DEPARTMENT OF LABOR

Occupational Safety and Health Administration

Walking-Working Surfaces, Personal Protective Equipment (Fall Protection Systems), and Special Industries (Electric Power Generation, Transmission, and Distribution); Corrections

ACTION: Final rule; corrections to standards.

Figure D-8 – Dimensions of Standard Stairs

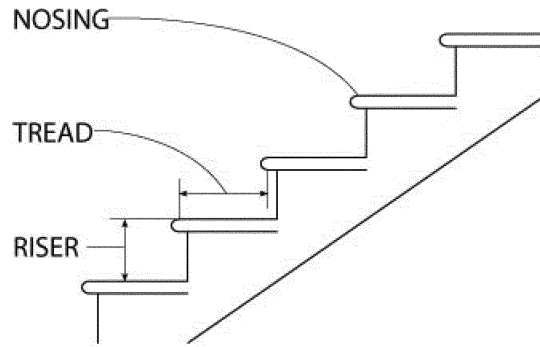
The figure at 29 CFR 1910.25(c) immediately after Table D-1 does not have a title even though it is referred to as Figure D-8 in § 1910.25(c)(4). The title of the figure was included in the proposed rule (75 FR at 29137) but mistakenly left out of the final rule (81 FR at 82989). This document adds the missing title to the figure: “Figure D-8—Dimensions of Standard Stairs”.

■ 3. Amend § 1910.25 by revising paragraph (a) and the figure following Table D–1 in paragraph (c)(5) to read as follows:

MINIMUM TREAD WIDTH 22 IN (56 CM)
 MINIMUM TREAD DEPTH 9.5 IN (24 CM)
 MAXIMUM RISER HEIGHT 9.5 IN (24 CM)

Figure D-11 Guardrail Systems

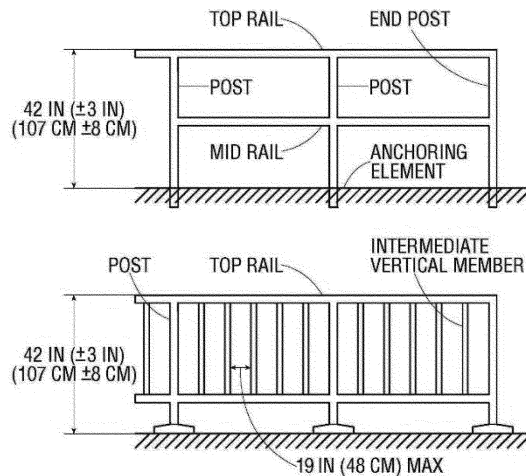
OSHA is correcting Figure D-11 to include labels identifying the top rail and end post in the top diagram of the figure. The words “top rail” and “end post” were mistakenly omitted when the final rule was published in the **Federal Register** (81 FR at 82995).

■ 5. Amend § 1910.29 by revising paragraph (b)(1) and Figure D-11 to read as follows:

(1) The top edge height of top rails, or equivalent guardrail system members, are 42 inches (107 cm), plus or minus 3 inches (8 cm), above the walking-working surface. The top edge height may exceed 45 inches (114 cm), provided the guardrail system meets all other criteria of paragraph (b) of this section (see Figure D-11 of this section).
